TELEVISION TECHNICAL BULLETIN

MODELS 66DW18H 76DW18H

Reference AM270799

Location of R1810, R1811 and R1812 on the CRT PWB

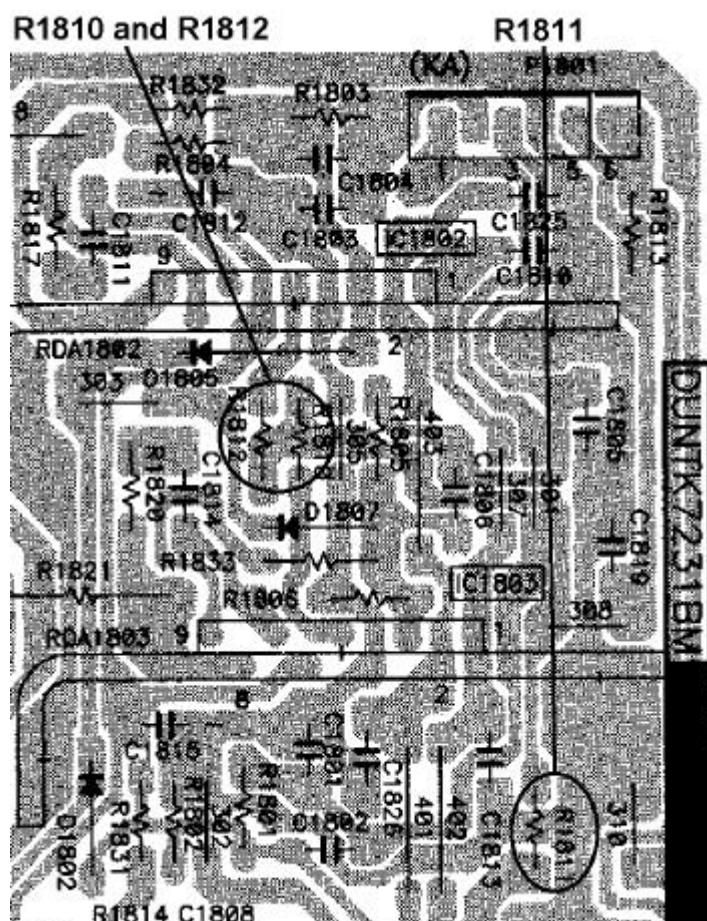
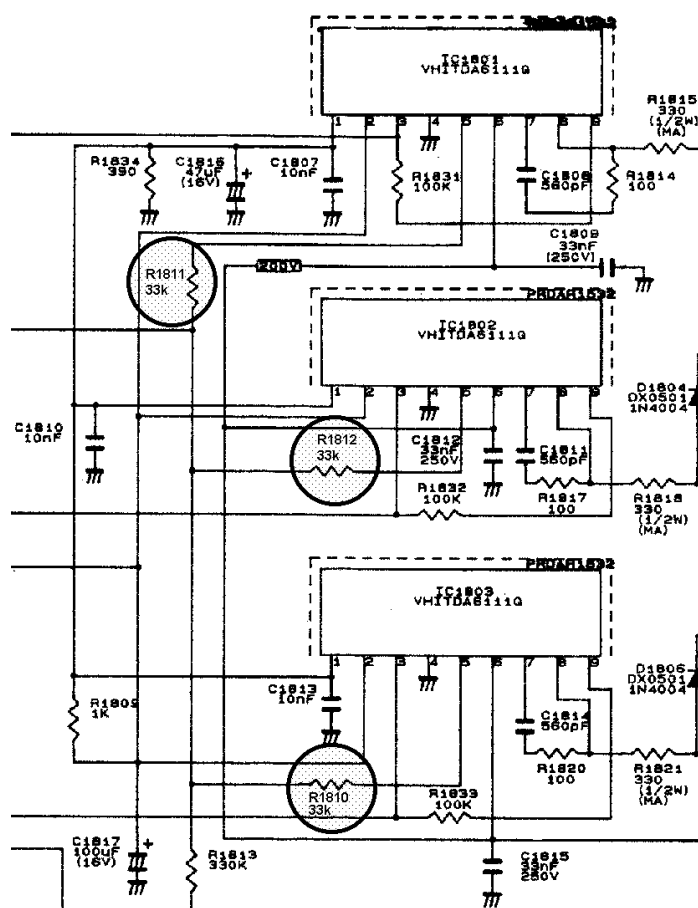
SYMPTOM No picture - blank raster.

CAUSE R1810, R1811 and R1812 changing in value.

ACTION Replace R1810, R1811 and R1812.

REF NO	DESCRIPTION	PART NUMBER	PRICE CODE
R1810	Resistor 33k Ω , 1/8W	VRD-RA2BE333J	AB
R1811	Resistor 33k Ω , 1/8W	VRD-RA2BE333J	AB
R1812	Resistor 33k Ω , 1/8W	VRD-RA2BE333J	AB

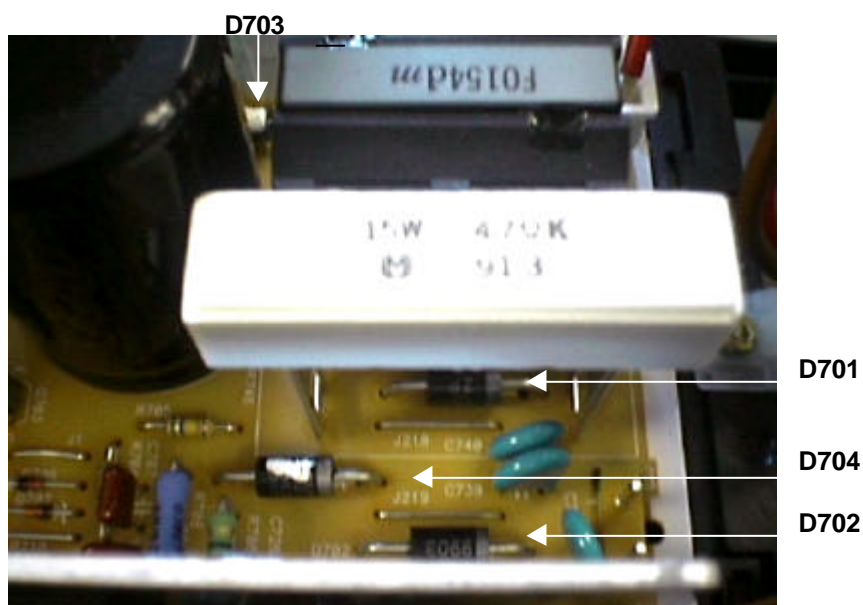
SYMPTOM The reciever does not turn on - mains fuse blown.

CAUSE Bridge rectifier diodes short circuit (D701, D702, D703 and D704).

ACTION Replace D701, D702, D703 and D704 with the part specified below.

Location of R1810, R1811 and R1812 on the CRT PWB

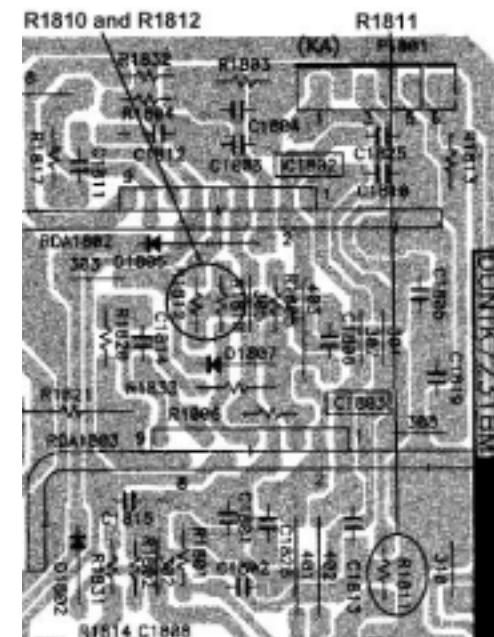
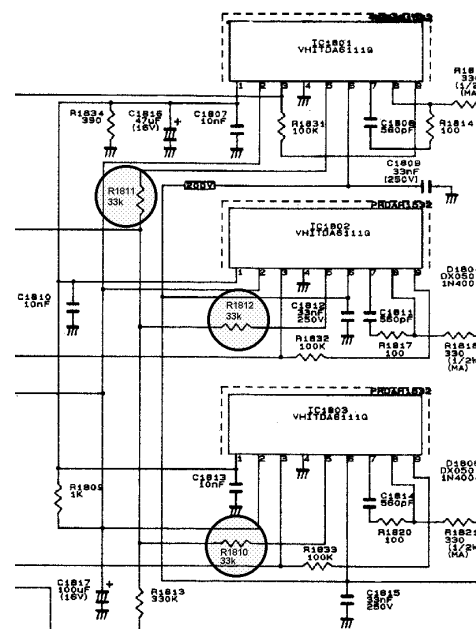
SYMPTOM No picture - blank raster.

CAUSE R1810, R1811 and R1812 changing in value.

ACTION Replace R1810, R1811 and R1812.

REF NO	DESCRIPTION	PART NUMBER	PRICE CODE
R1810	Resistor 33k Ω , 1/8W	VRD-RA2BE333J	AB
R1811	Resistor 33k Ω , 1/8W	VRD-RA2BE333J	AB
R1812	Resistor 33k Ω , 1/8W	VRD-RA2BE333J	AB

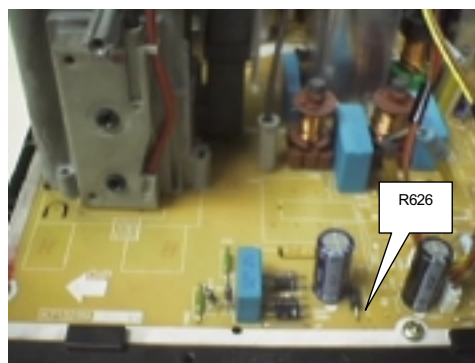
SYMPTOM Failure of Q509.

CAUSE Excessive excursions of the positive forty volt supply from the line stage.

ACTION Fit an extra zener diode, D632, in the position of R626 as shown in the diagram below.

REF NO	DESCRIPTION	PART NUMBER	PRICE CODE
D632	Zener diode, 47V	RH-EX0431BMZZ	AA

THOMSON PICTURE TUBE

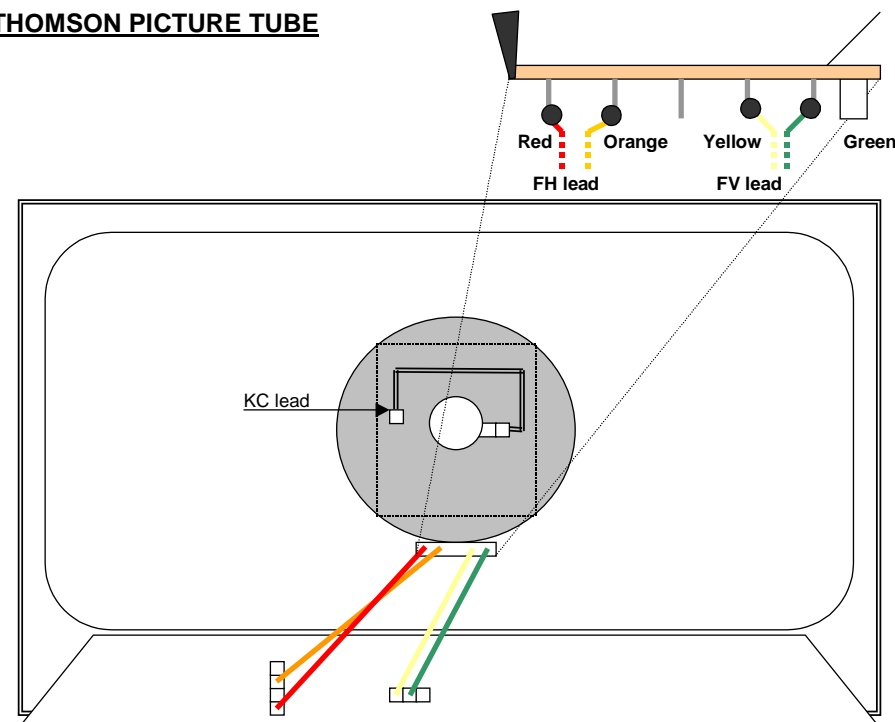
To change the deflection yoke wiring from a Philips CRT to a Thomson CRT, proceed as follows.

1. Unsolder the red and orange FH leads from the deflection yoke.
2. Remove connector 1 from the yellow and green leads.
3. Strip the yellow and green wires of insulation (about 4mm).
4. Solder the red and orange (FH) leads as shown above.
5. Solder the yellow and green (FV) leads as shown above.
6. Replace lead KC (QCNW-2757BMZZ) connects the CRT socket to the neck of the CRT with QCNW-2775BMZZ type.

PHILIPS CRT Original deflection yoke PWB shown on left

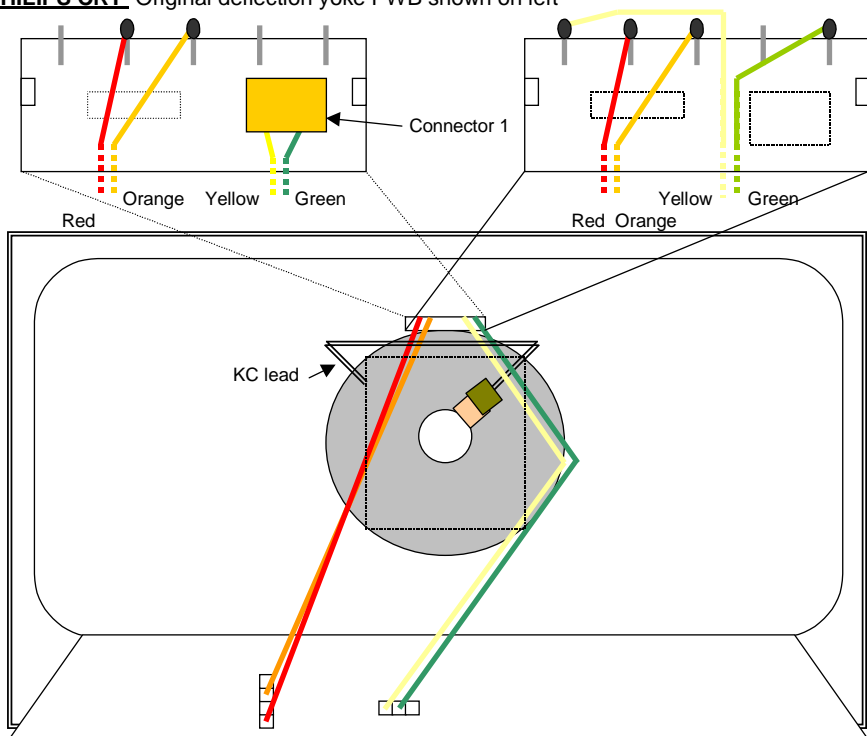
To change the deflection yoke wiring from a Thomson CRT to a Philips CRT, proceed as follows

1. Unsolder both the green and yellow (FV) and red and orange (FH) leads from the deflection yoke PWB.
2. Solder these leads to the Philips CRT as shown above.
3. Replace wire KC (QCNW-2775BMZZ) that connects from the CRT socket PWB to the neck of the CRT with lead QCNW-2757BMZZ.
